EN 1997-1:2004/AC

Eurocode 7: Geotechnical design - Part 1: General rules

This corrigendum becomes effective on 18 February 2009 for incorporation in the three official language versions of the EN.

Figure 10.1 d)

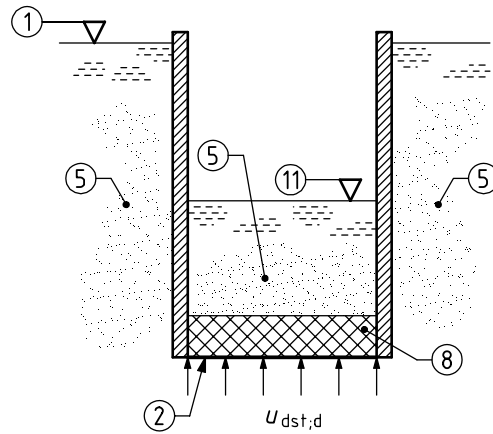
Figures 10.1 c) and d), add the key element:

“11 groundwater level in the excavation”.

In Figure 10.1 d), delete the key element:

“6 sand”.

Figure C.1.1 — Coefficients K_a of effective active earth pressure (horizontal component): with horizontal retained surface ($\beta = 0$)

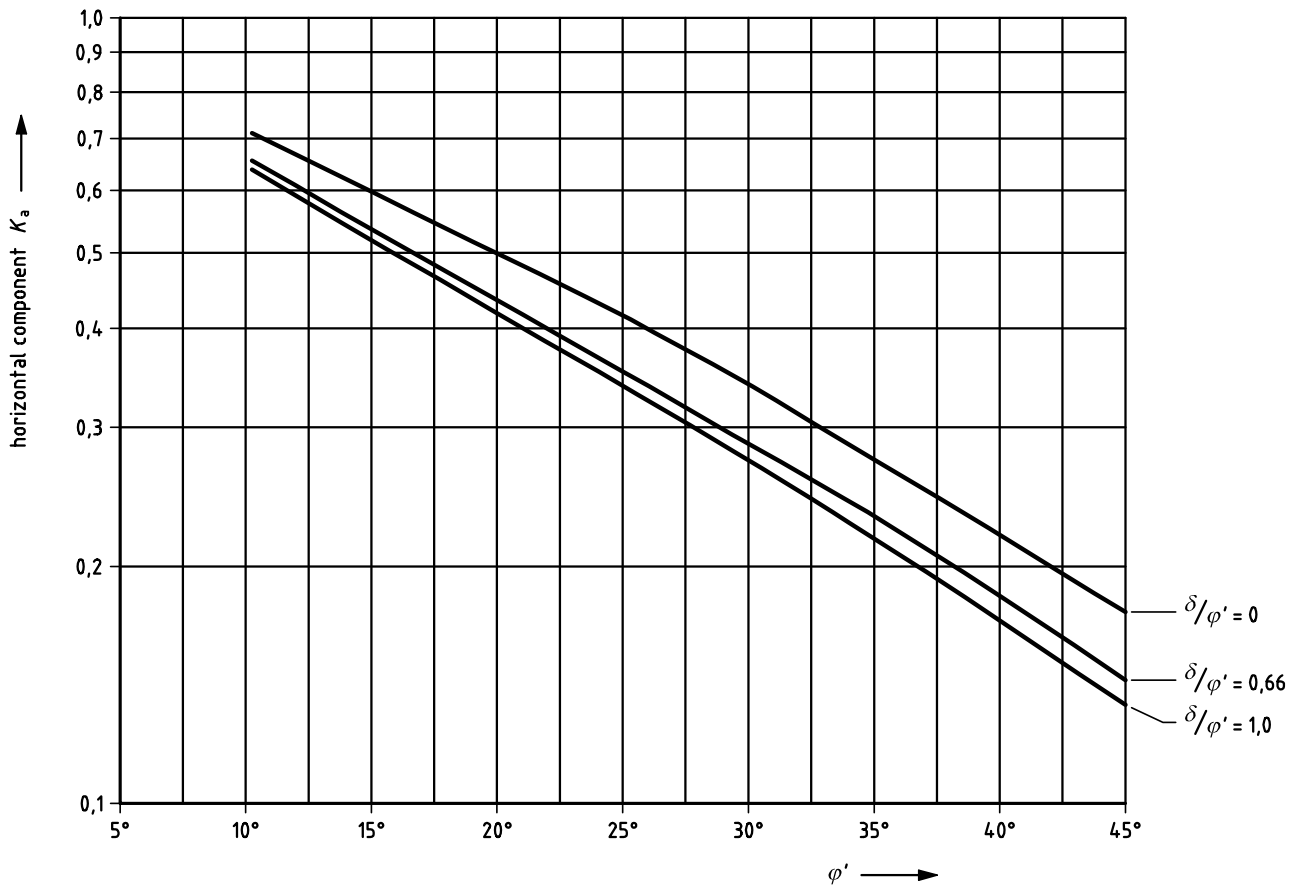
Replace the full Annex C with the following new Annex C:

(3) Values of the effective earth pressure coefficients may be taken from Figures C.1.1 to C.1.4 for K_a and C.2.1 to C.2.4 for K_p .
